AeroConversions Rotax Engine Mount Attach Kit Installation Instructions		
Drawing Scale FULL & Noted	Drawing Number ACV-P54-Kit	Revision B

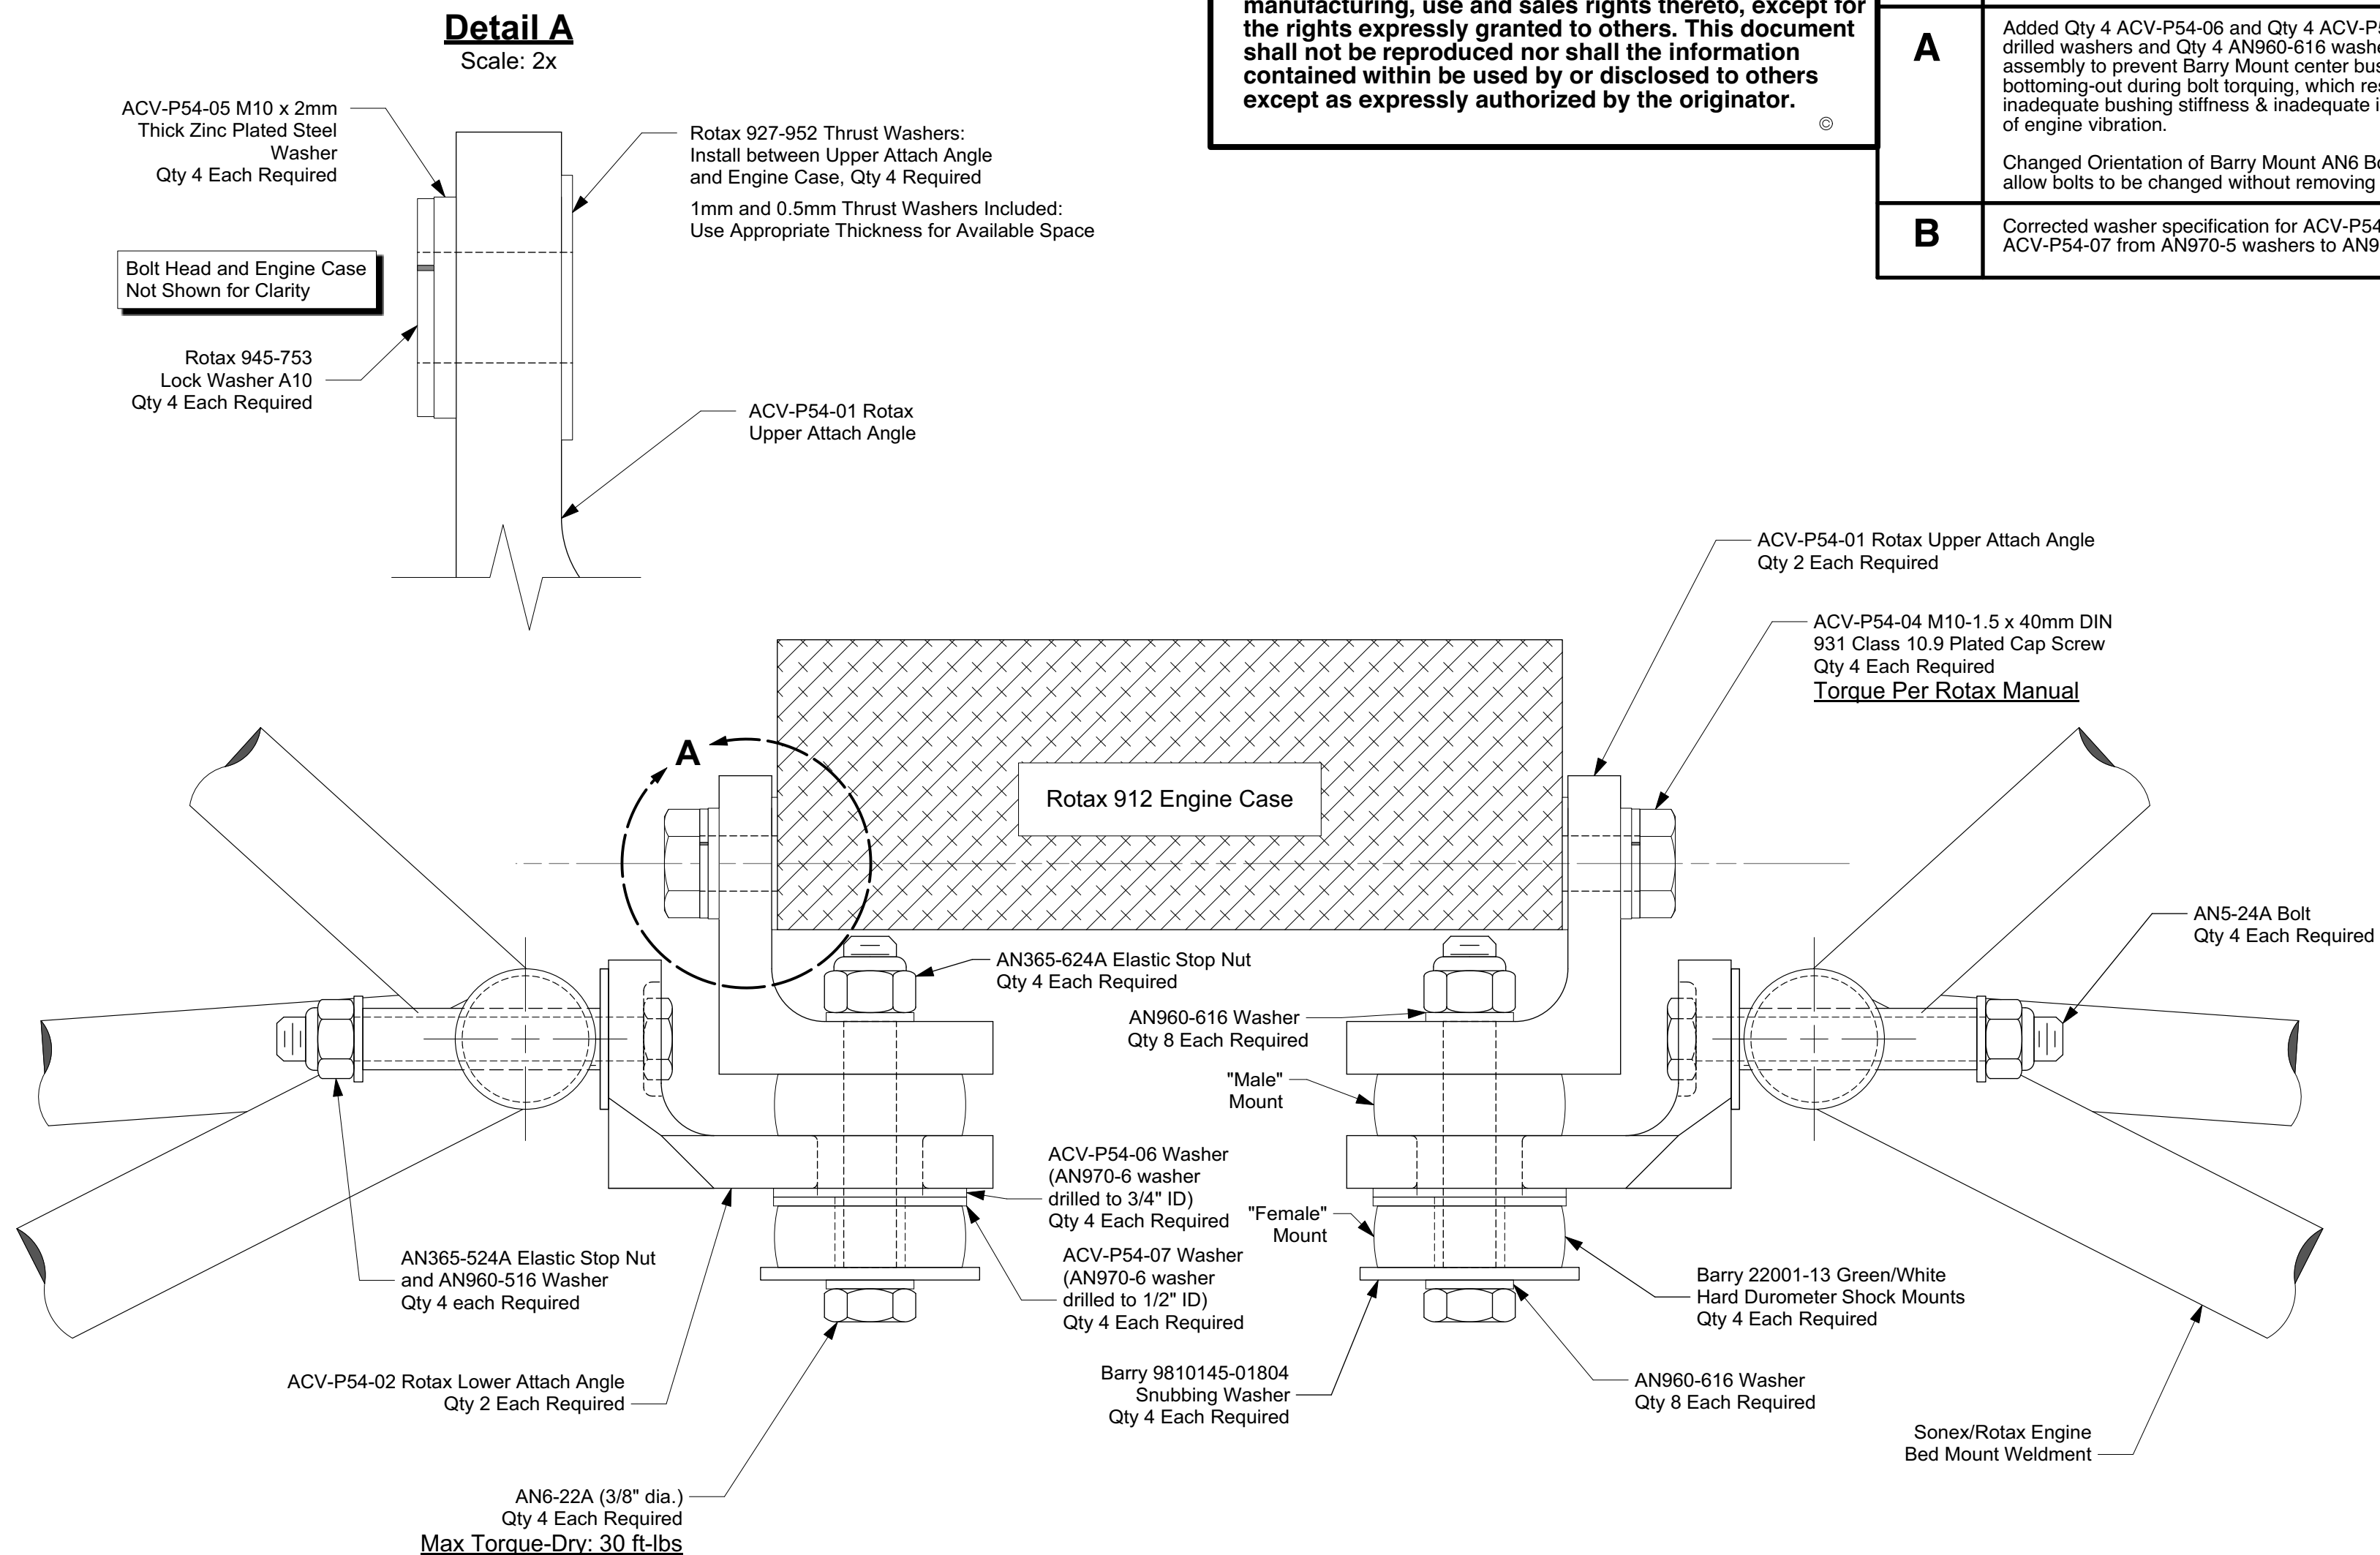
Revision Letter	Change Description	Date
A	Added Qty 4 ACV-P54-06 and Qty 4 ACV-P54-07 drilled washers and Qty 4 AN960-616 washers to assembly to prevent Barry Mount center bushings from bottoming-out during bolt torquing, which results in inadequate bushing stiffness & inadequate isolation of engine vibration. Changed Orientation of Barry Mount AN6 Bolts to allow bolts to be changed without removing engine.	10/04/22
B	Corrected washer specification for ACV-P54-06 and ACV-P54-07 from AN970-5 washers to AN970-6.	08/29/23
